Request for City Manager Signature

Project Name/Contract Number:	IH35 at SH123 Bridge Aux Lanes	#0016-03114
Department Contact / Department Name:	Rohit Vij	CIP/Engineering
Date of City Council Approval: (Past or Recent)	2021-31R; March 24, 2021 (Past Approval Date – Contract 0016-03114) August 12, 2021 (AFA Amendment #1) February 17, 2026 (Anticipated Approval Date – SUPP & AFA Amendment #2)	
Return Signed Document to:	Rohit Vij	Ext: 8133

Standard Utility Agreement Supplemental Agreement No. 1 to U Number 15694 Utility ID 00000284

District: Austin
ROW Project ID: R00002549
ROW CSJ: 0016-03-115
Construction CSJ: 0016-03-114
Proposed Highway Project Letting Date: 04/01/2021

**IH 35 AT SH 123
WATER MAIN
PLAN AND PROFILE**

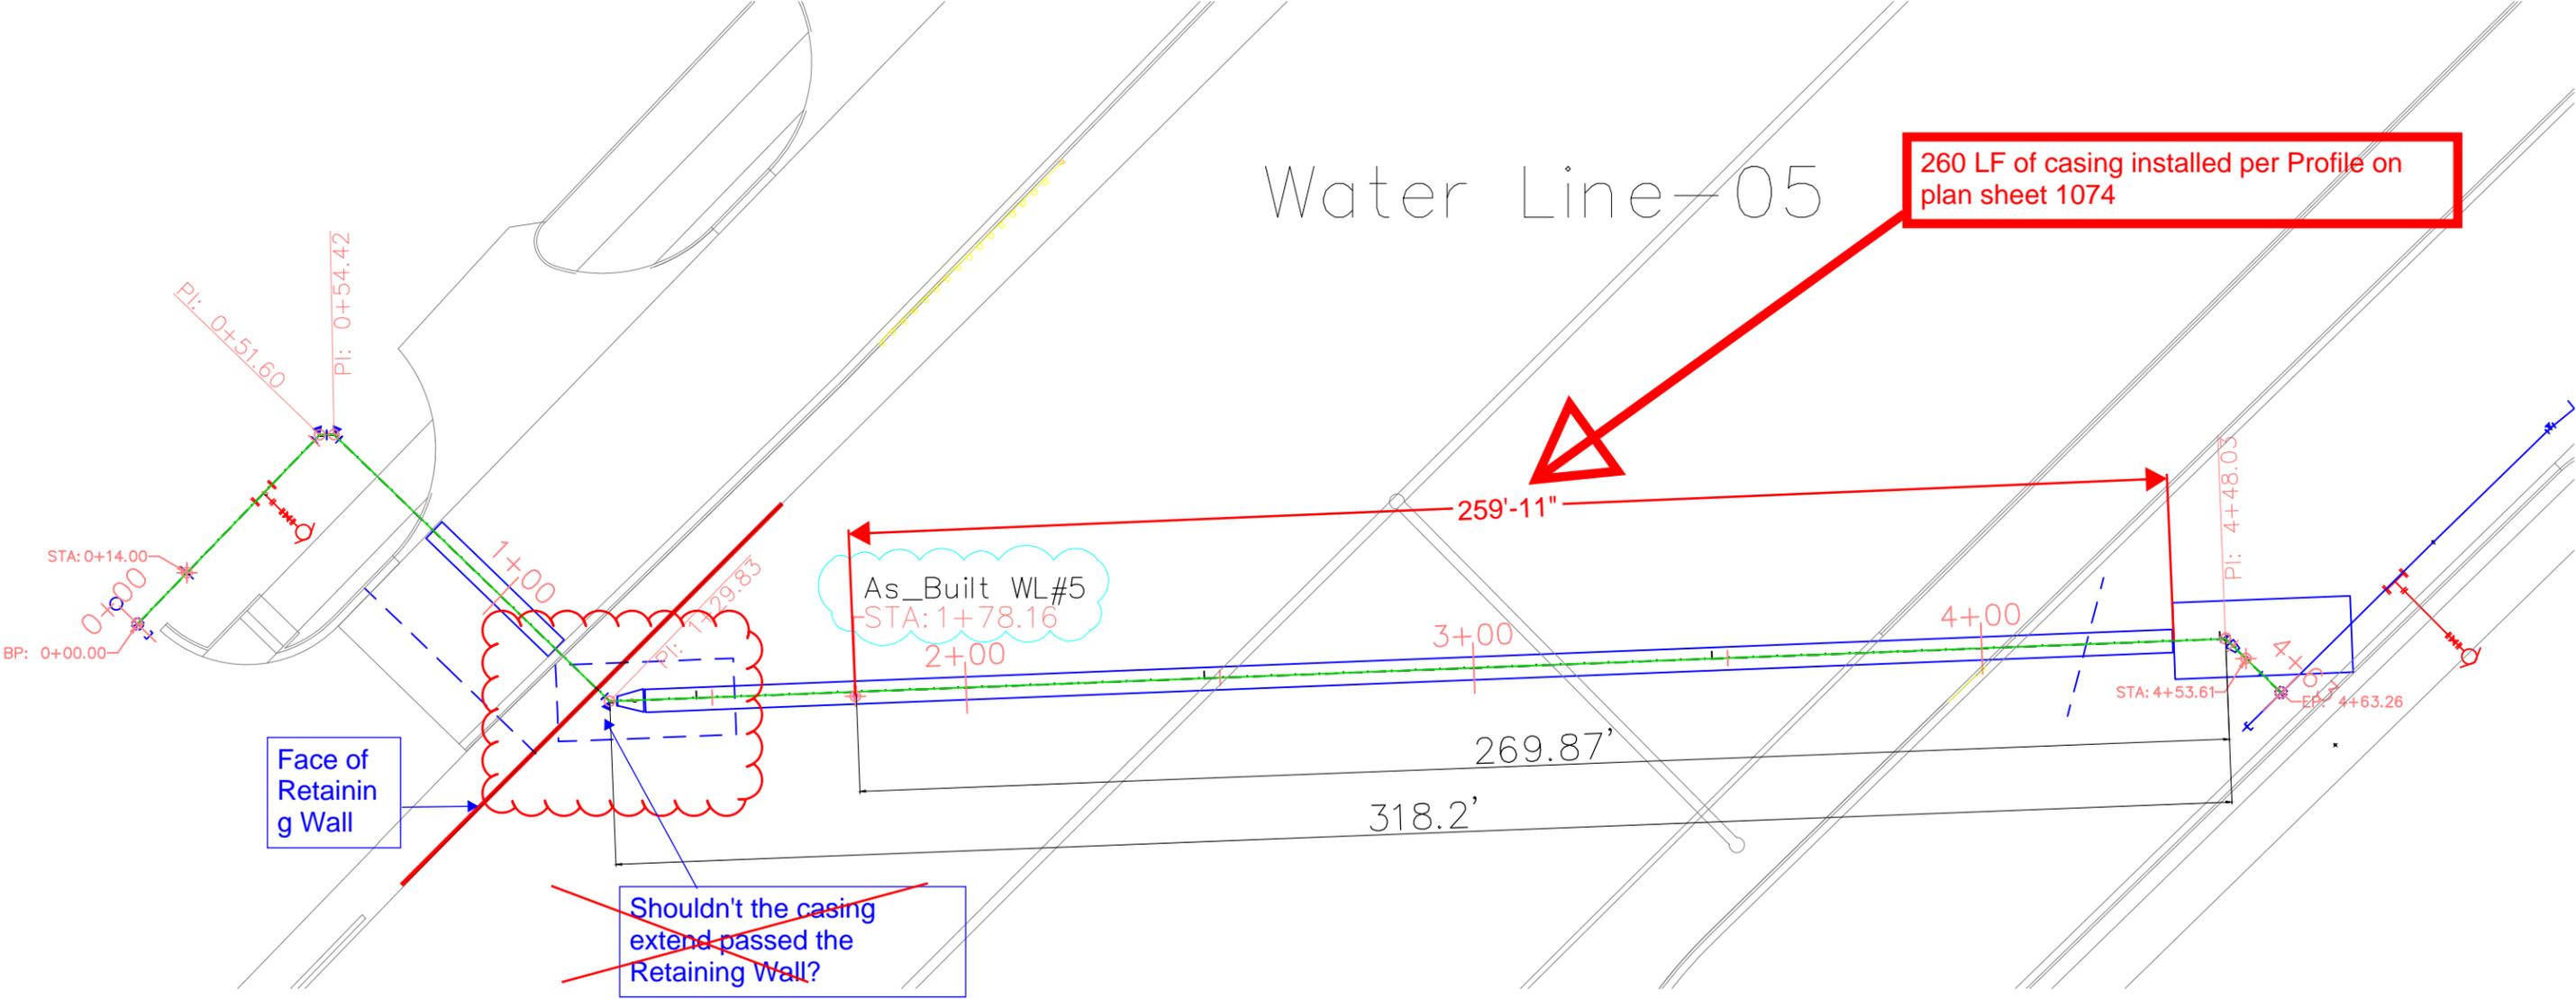
260 LF of casing installed per Profile on plan sheet 1074

**IH 35 AT SH 123
 WATER MAIN
 PLAN AND PROFILE**

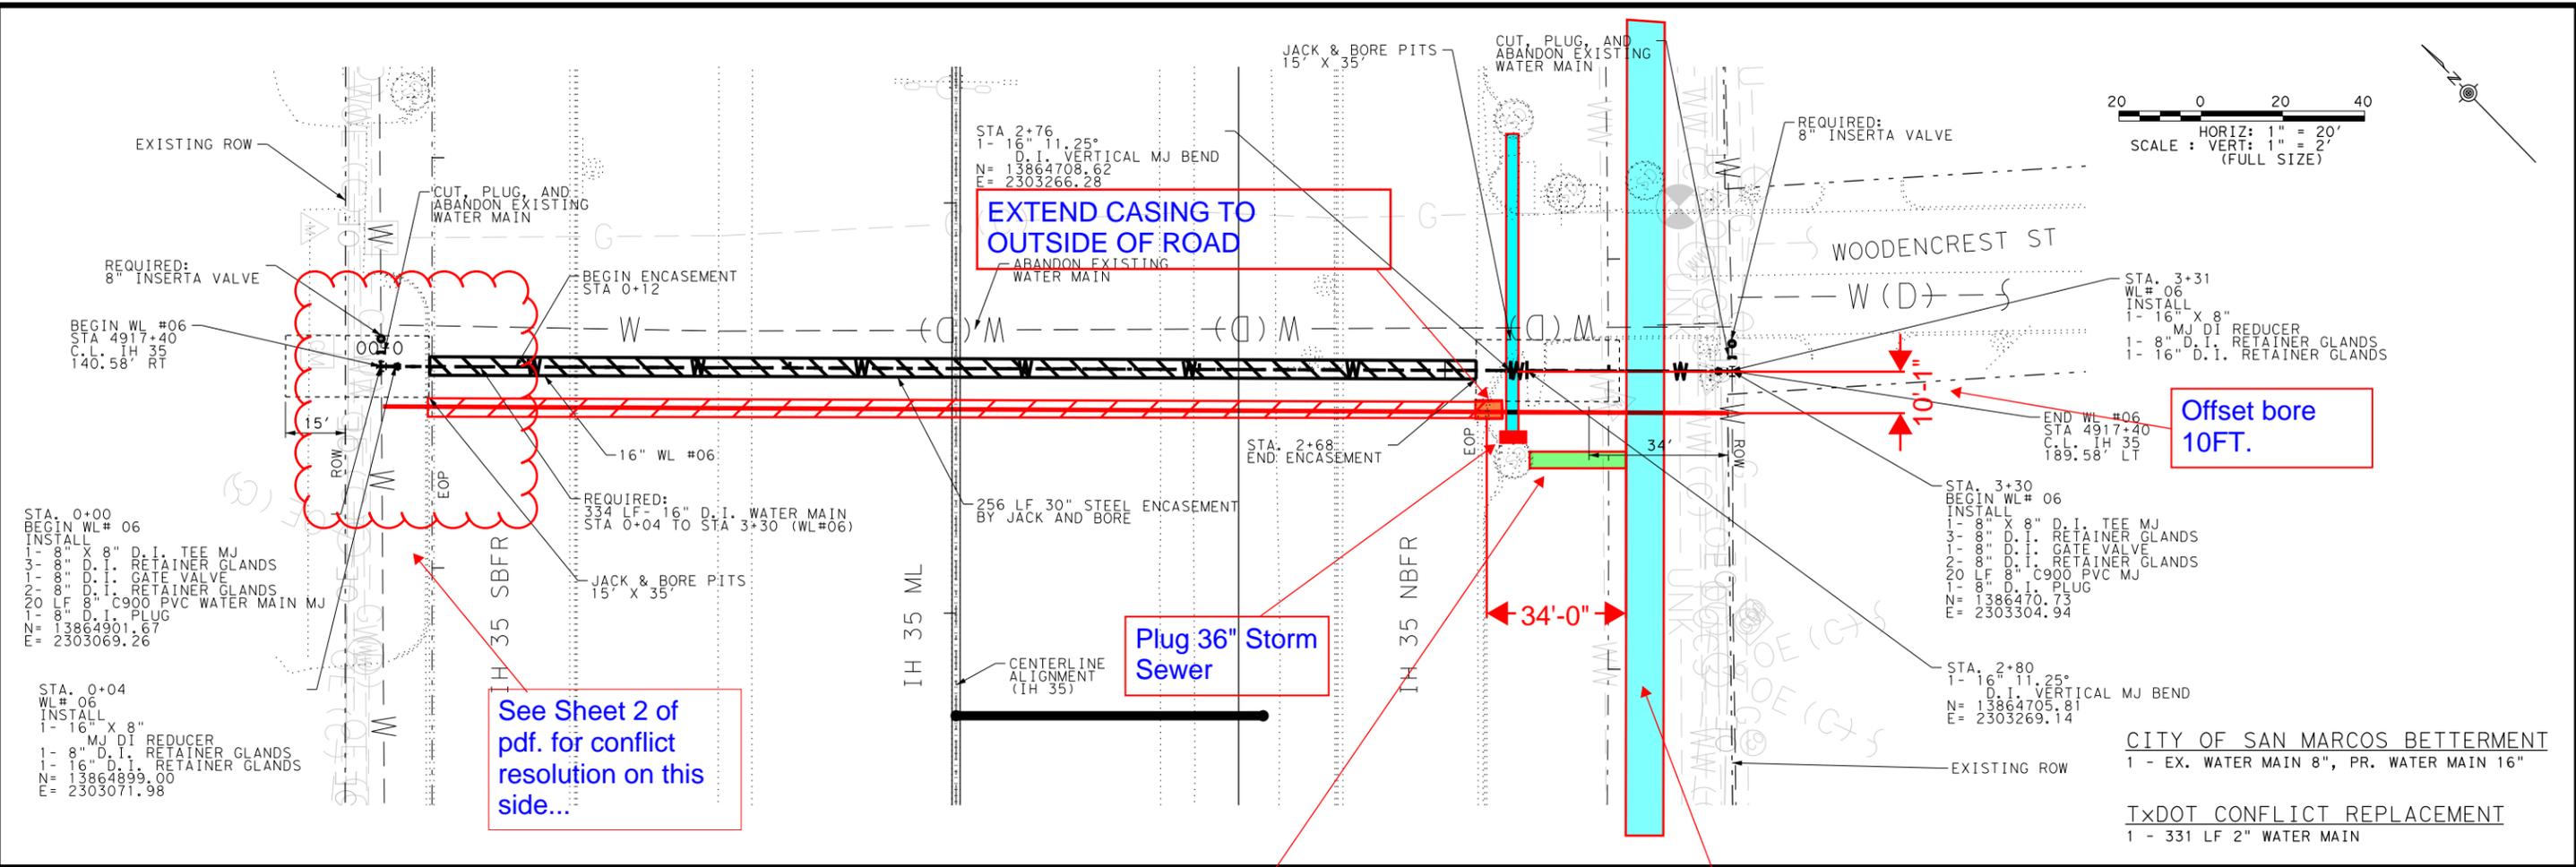
See Sheet 2 of pdf. for conflict resolution on this side...

**IH 35 AT SH 123
 WASTEWATER
 PLAN AND PROFILE**

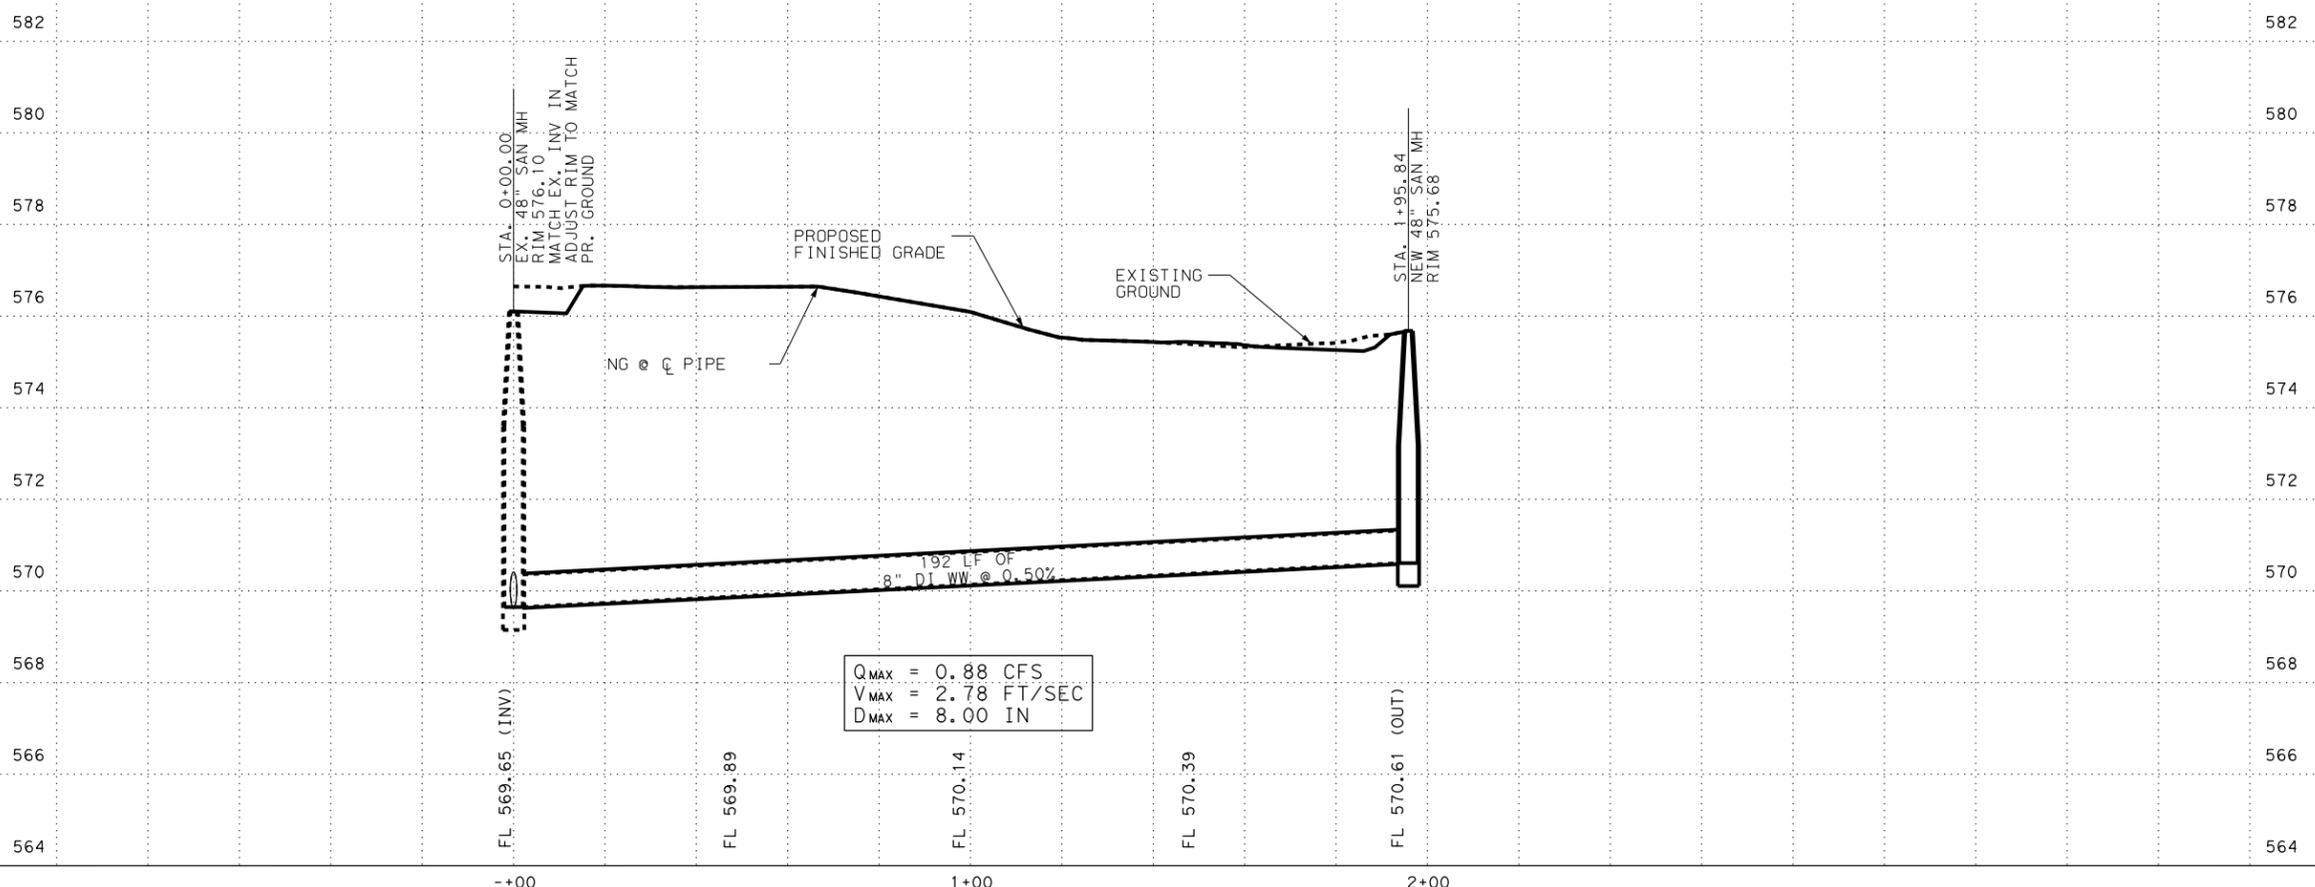
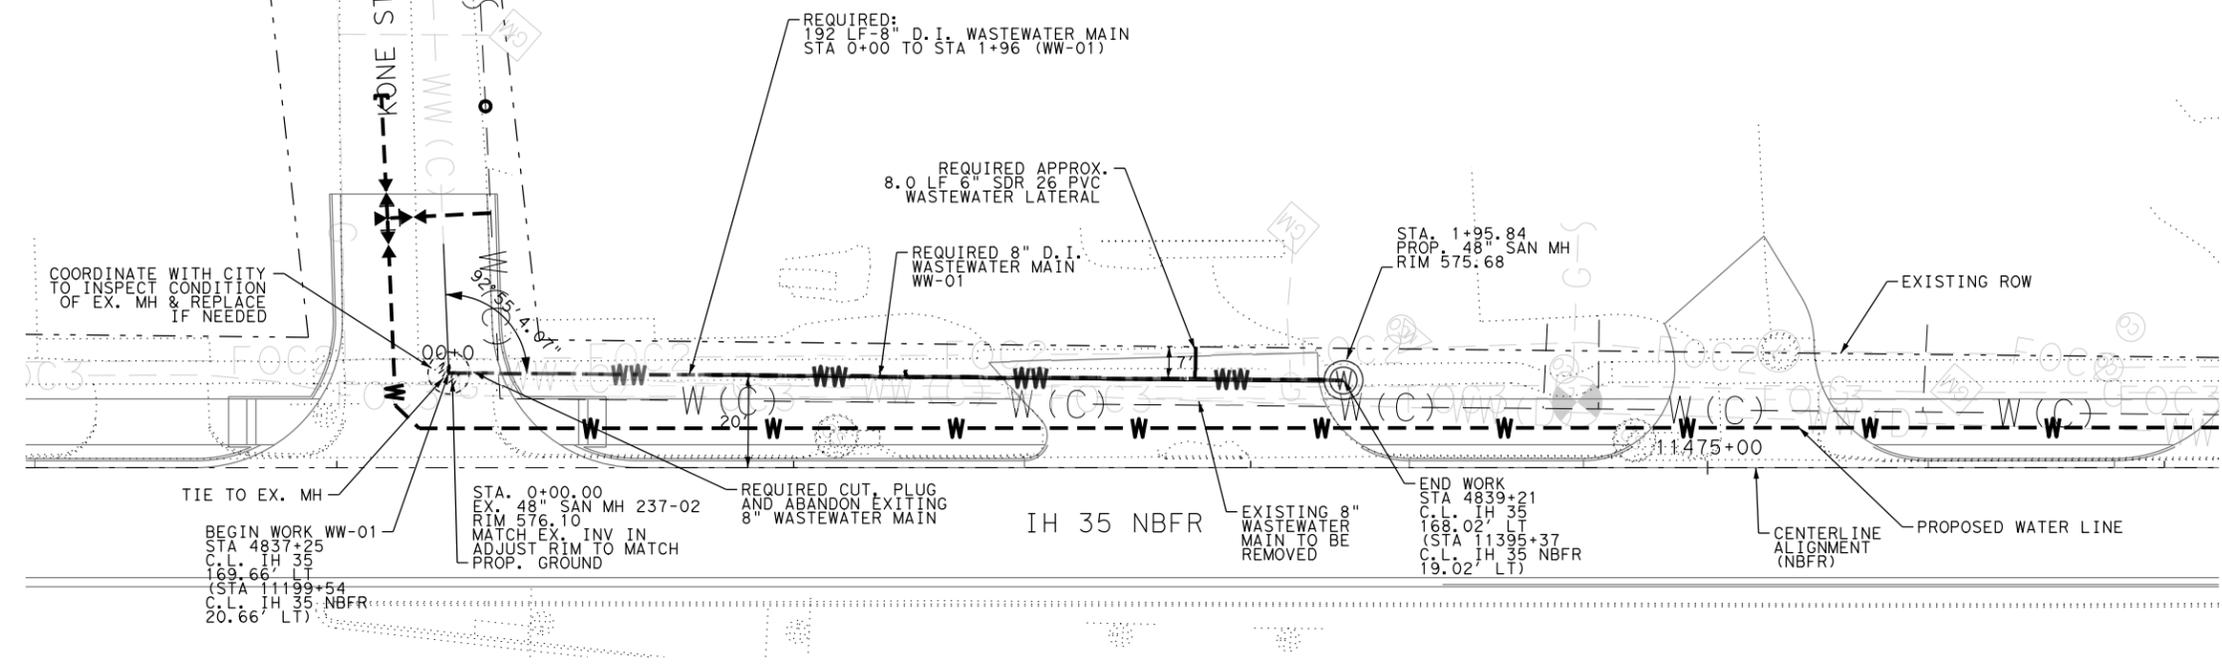
TxDOT CONFLICT REPLACEMENT
 1 - 196 LF WASTEWATER CONFLICT
